1984 - 1985 Corvette: Service Bulletin: Noise in Direct Drive 4-Speed Manual Transmission

Bulletin No: 85-111

Date: Aug., 1985

Figure 1

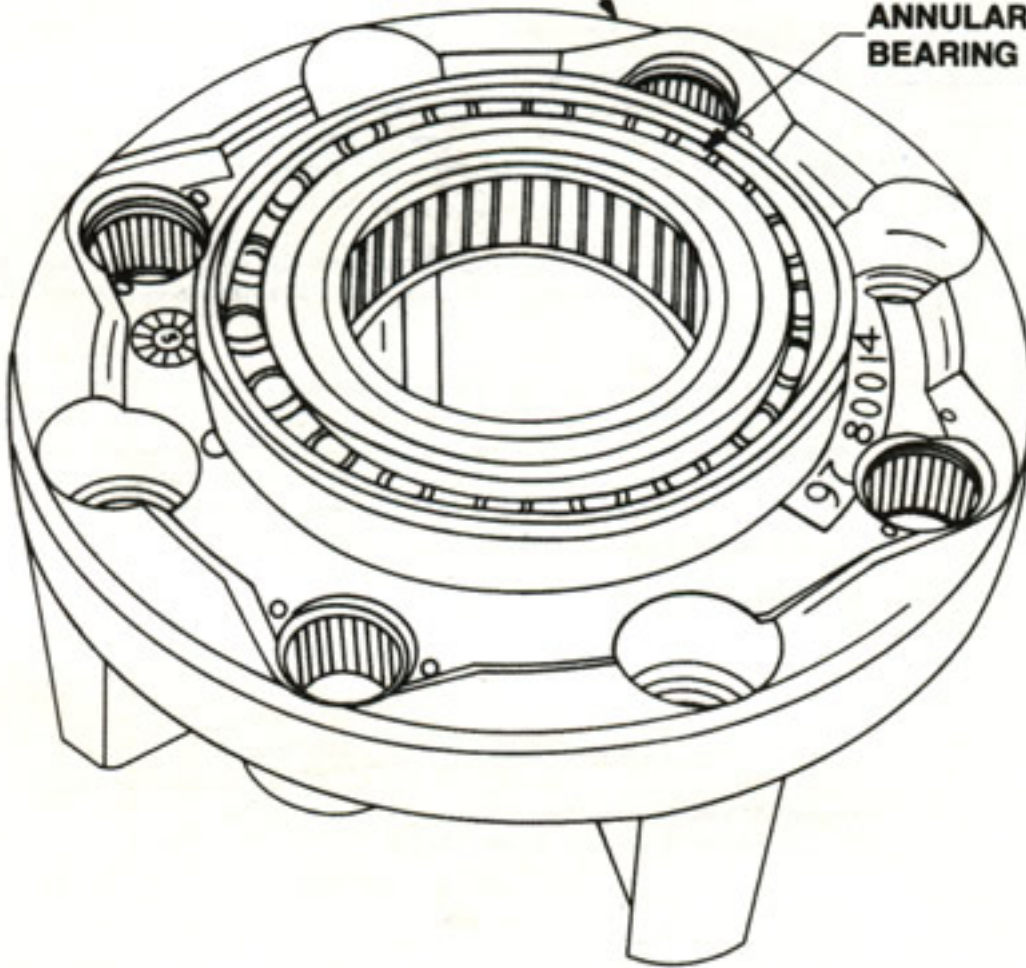
This condition may be caused by a worn annular bearing on the planetary gear carrier (see illustration). Continued operation of a noisy transmission in the direct drive model will cause damage to the planetary carrier, adapter plate, input sun gear, and input sun gear oil seal. If the input sun gear oil seal is damaged, it is possible for overdrive unit oil (Dexron II) to leak into the manual portion of the transmission.

On transmissions beginning with serial number D5C 14413 CF, a new planetary gear carrier has been released. This carrier (P/N 14094571) incorporates an annular bearing with increased thrust capacity.

1. Inspect the adapter plate surface, input sun gear, and input sun gear oil seal for damage. If there is indication of damage, the adapter plate, input sun gear, and input sun gear oil seal should be replaced. If there is no sign of damage, these parts may be reused.
2. If debris is present in the overdrive unit, completely disassemble and clean the unit, including the valve body. Thoroughly flush the cooler lines to remove any debris following the procedure outlined in the Vehicle Service Manual. Replace the oil filter.
3. If there is evidence of oil intrusion from the automatic overdrive unit into the 4-speed manual unit, the manual unit should be drained and flushed also.
4. Replace the planetary gear carrier with the new, P/N 14094571, carrier.
